CITY OF ALBUQUERQUE

RE: **Lot 17 Block 1 Unit 22 SAD 228 Volcano Cliffs Subd.
8015 Agua Fria Ct. NW
Grading and Drainage Plan
Engineers Stamp Date 10/29/2020 (D10D003N17)
Pad Certification Date: 3/11/2021**

DRAINAGE AND TRANSPORTATION INFORMATION SHEET (REV 11/2018)

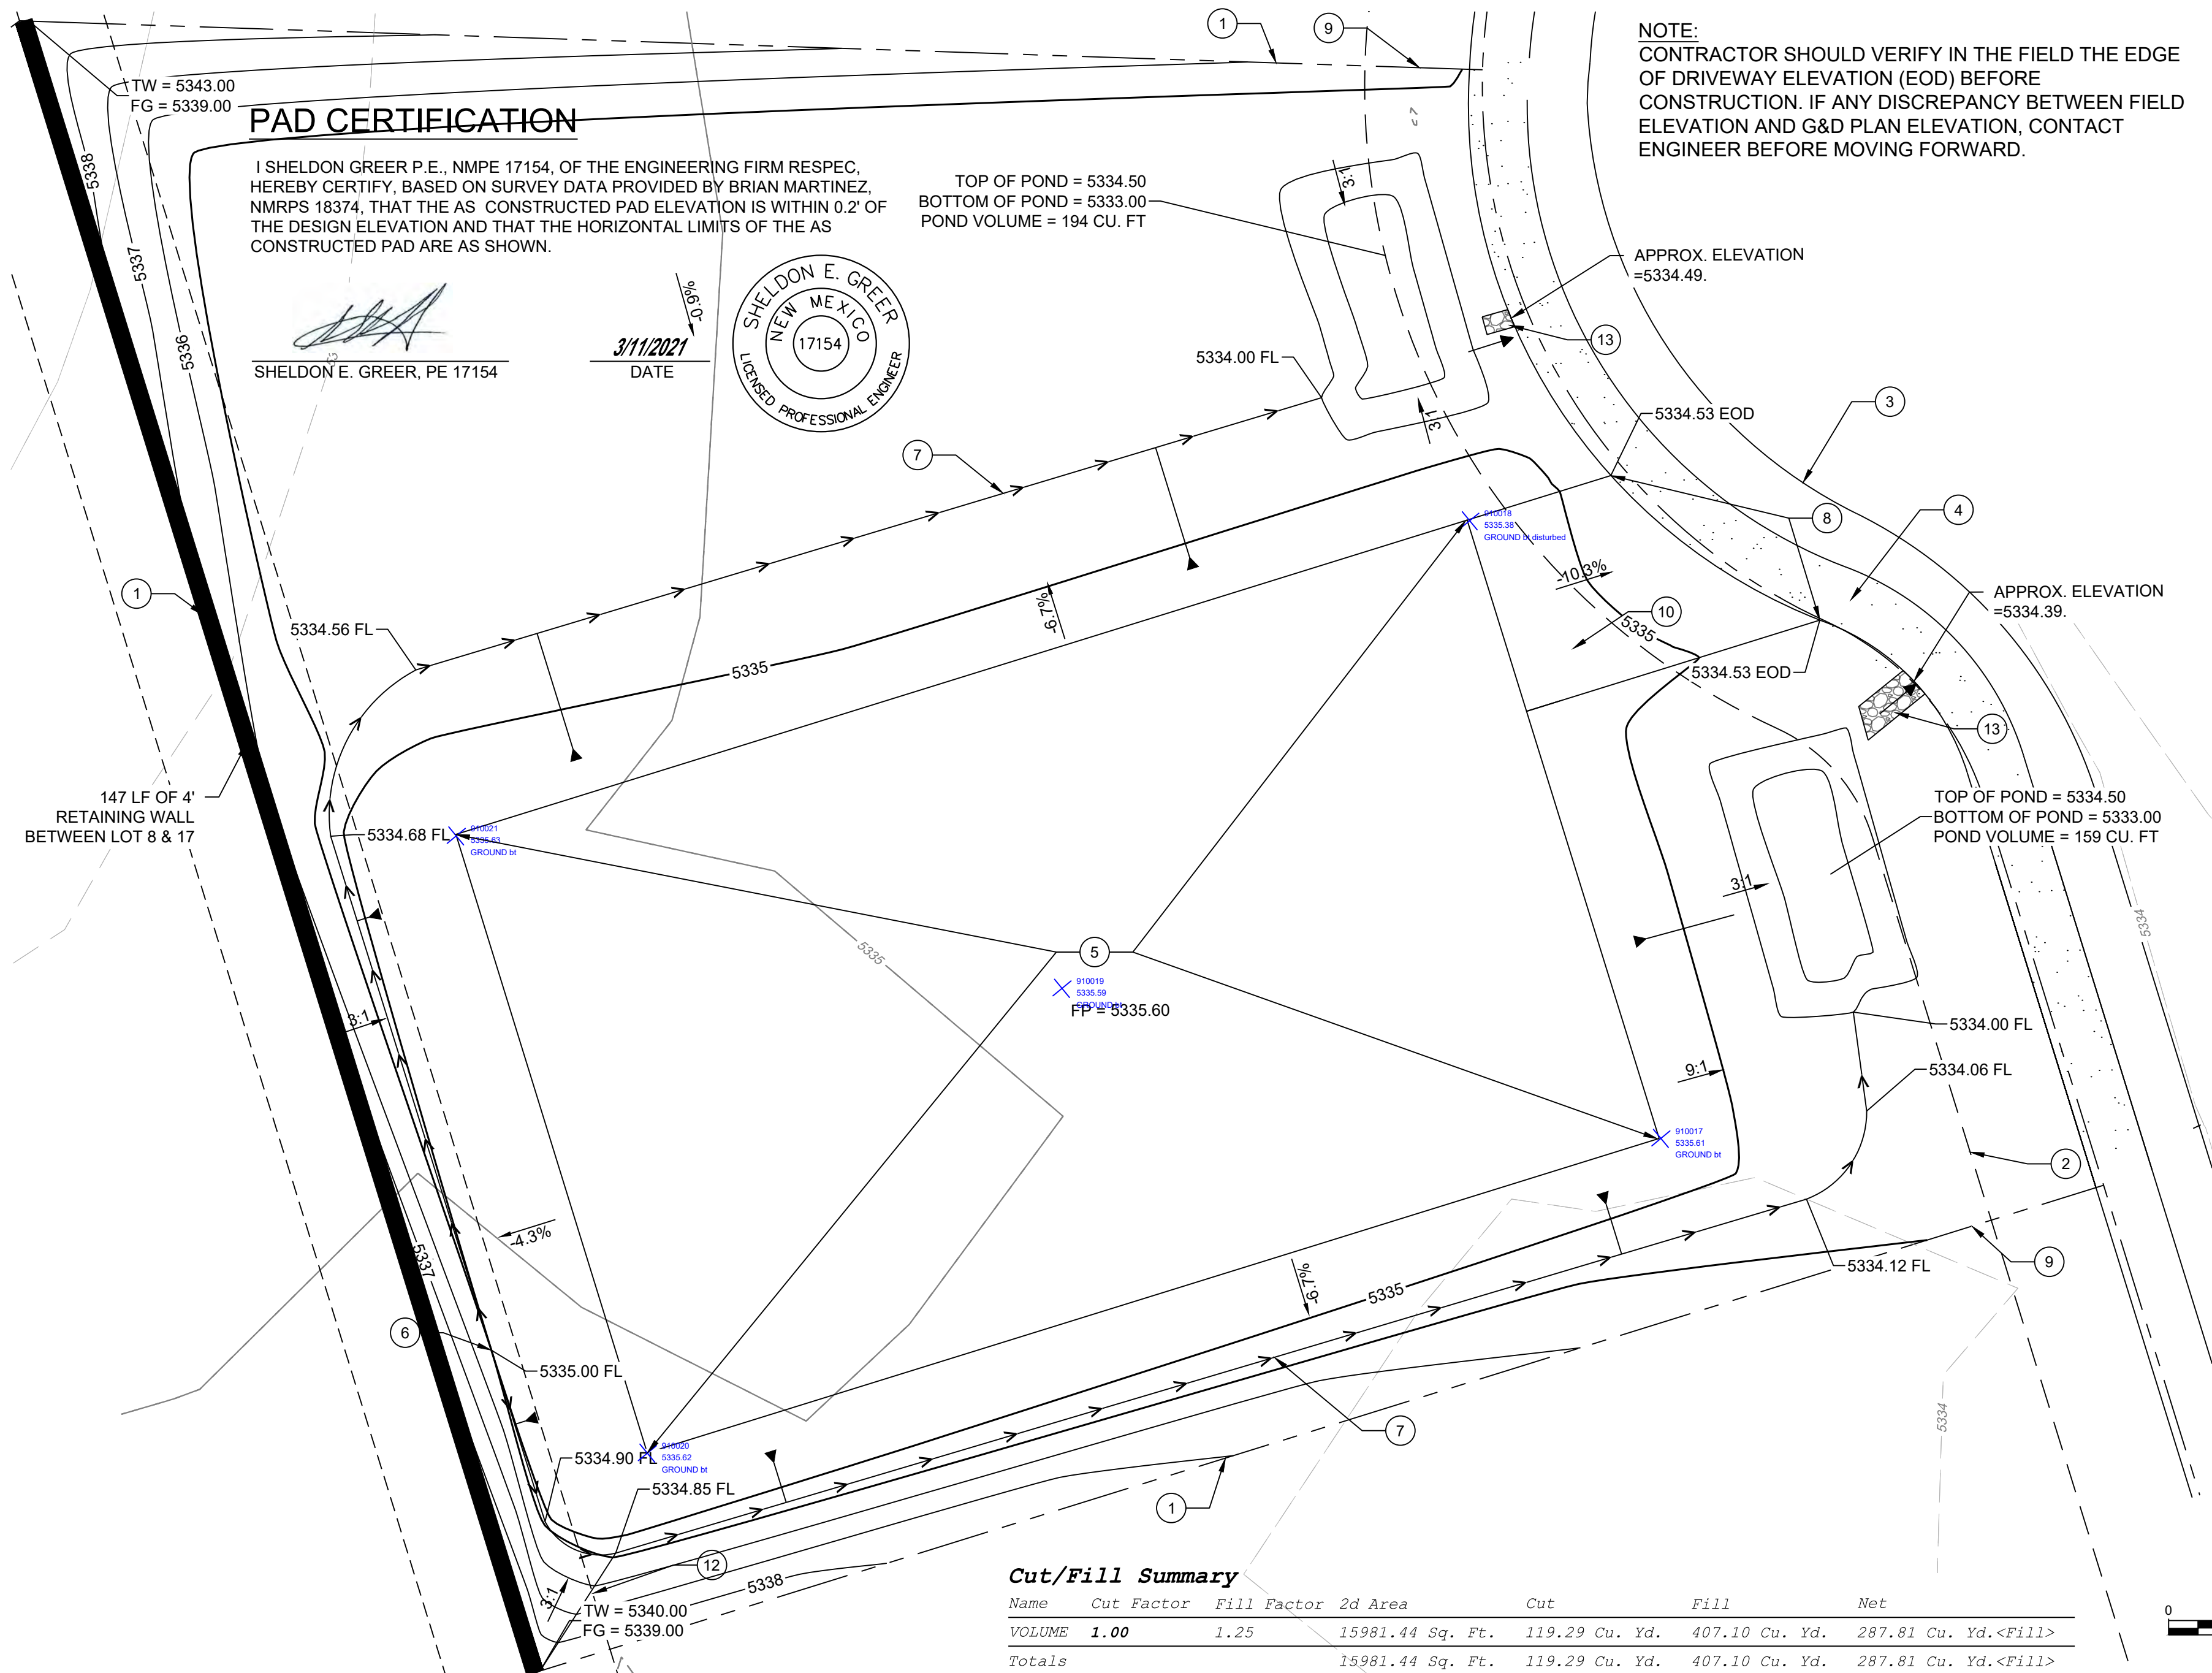
- Remove all dirt from the street. Dirt is not allowed to use as a ramp for going over the curb, only lumber or crusher fines are acceptable.
- Remove the dirt in the channel, it is blocking the flow from Alto Rey Ct. to Agua Fria Ct.

Reiterate to the Owner/Contractor that a separate permit for a garden/retaining wall must be obtained with the approved G&D plan and Pad Certification. **Also, if a swimming pool is to be placed the grading and drainage plan will change and will need to be resubmitted.**

Prior to Certificate of Occupancy release, Engineer Certification per the DPM checklist will be required.
